November 22, 2009

Addendum 2 to Yuma Pilot Center Project at Yuma International Airport

Concept Illustrations without Historic Aircraft Display

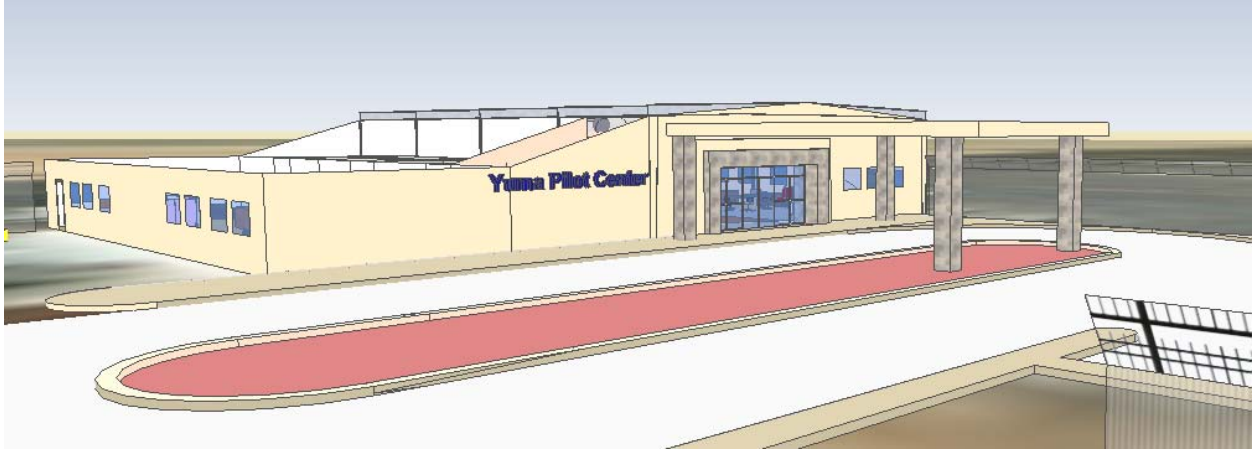
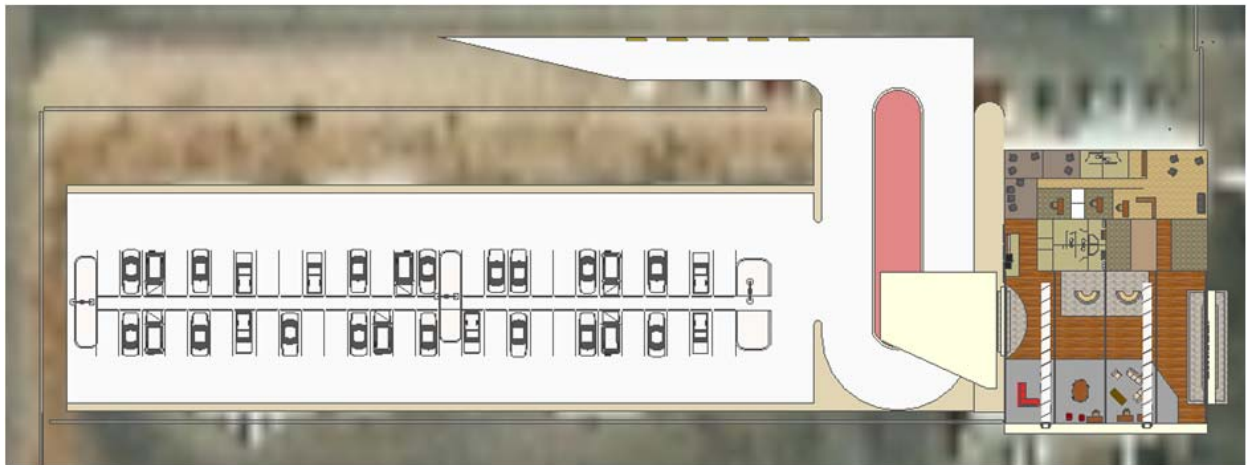
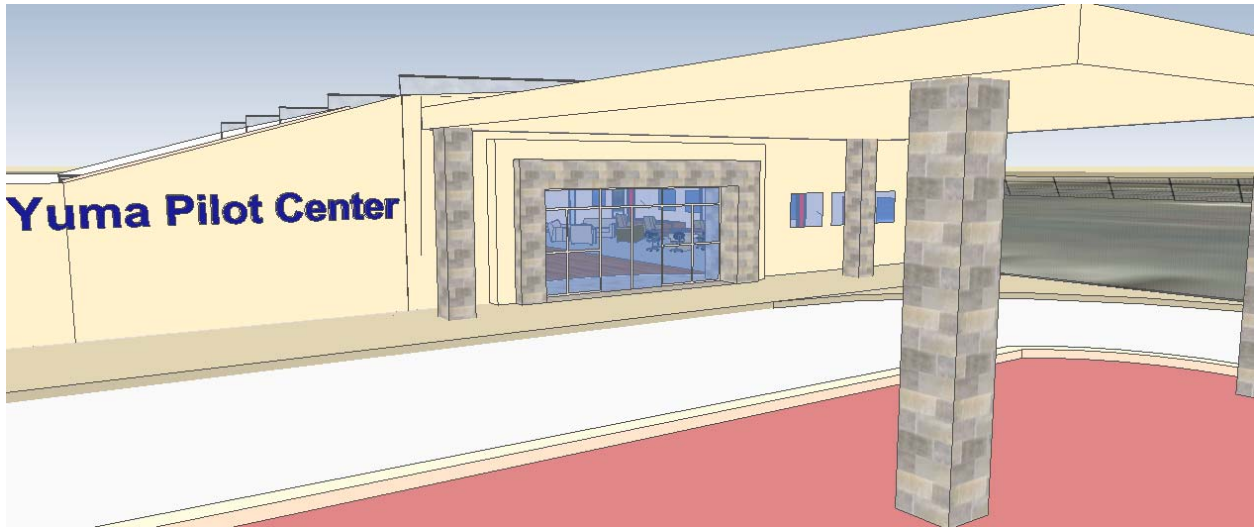
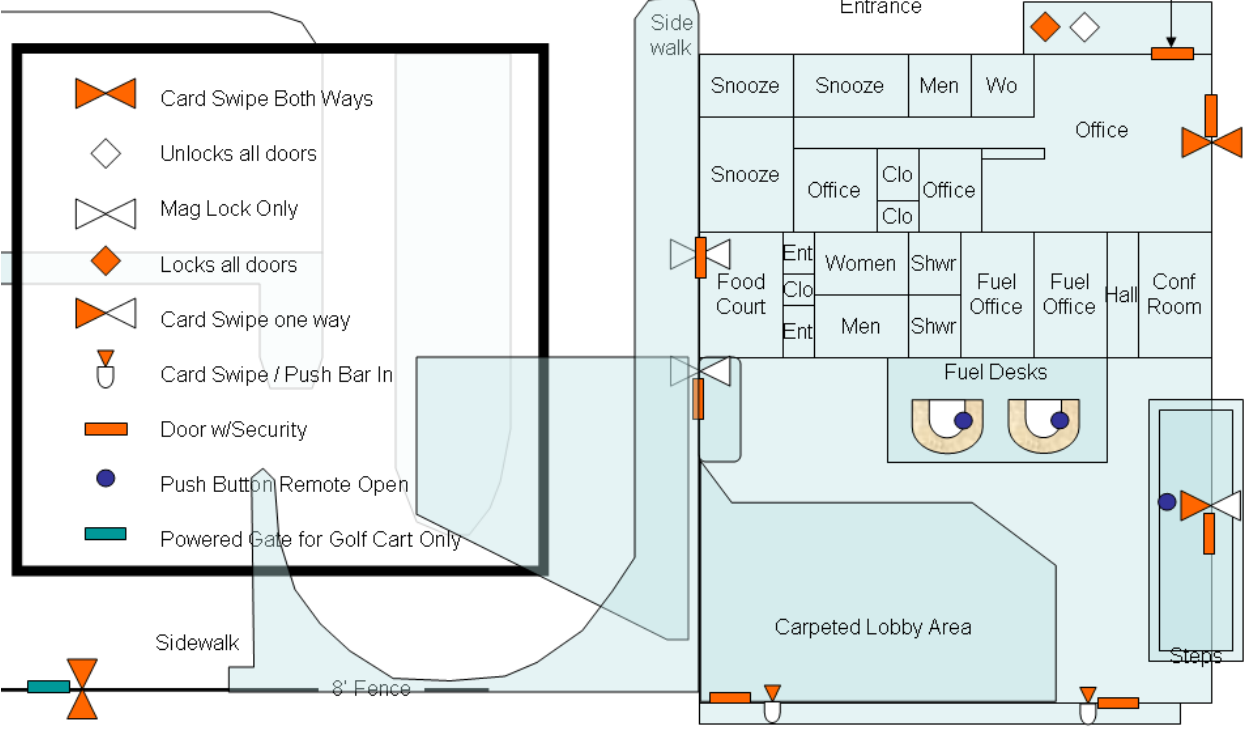
- 3) Additional Concept Drawings are included to indicate changes to the driveway and the landside façade/entryway. The landside and airside entryways now look very similar. Note the addition of the exterior sign on the landside. It was not included in earlier illustrations.

- 5) The pointy driveway in the concept illustrations is only meant to indicate a turn lane into the parking lot.

Figure 13 – Electrical in addition to code

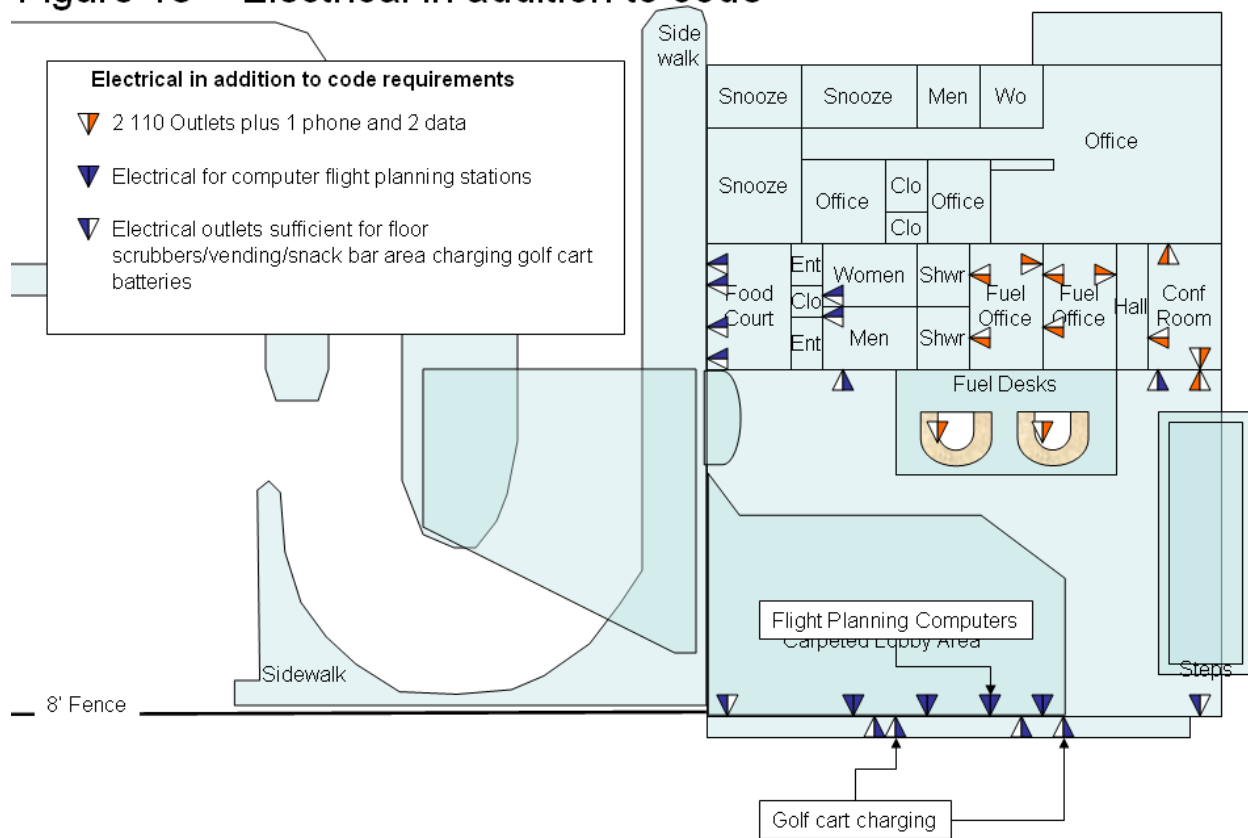
All exterior doors require mag locks for the Lock Down feature

Figure 1 - Nearest Sewer Line

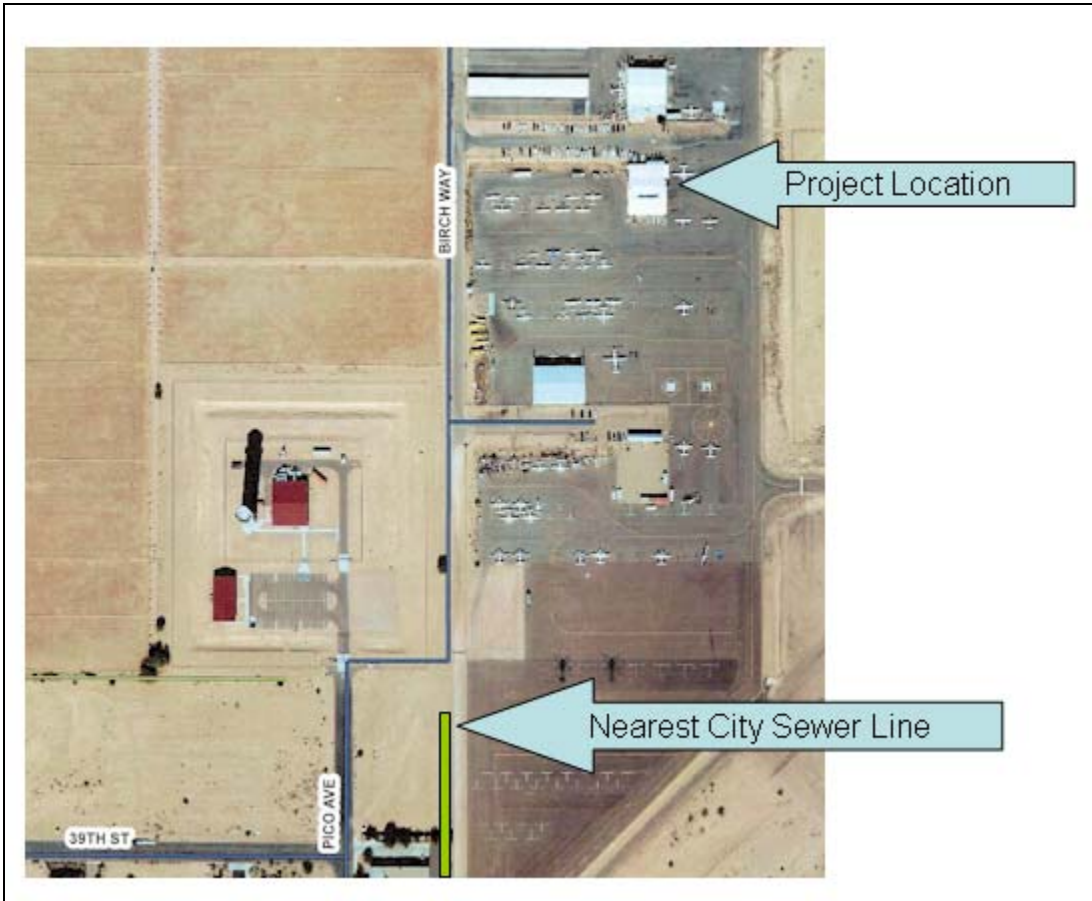
- The septic system must be approved by the City Inspector as sufficient. Otherwise, a connection will have to be made to the nearest city sewer, which is approximately 1,800 feet away as indicated in Figure 1 on page 8.
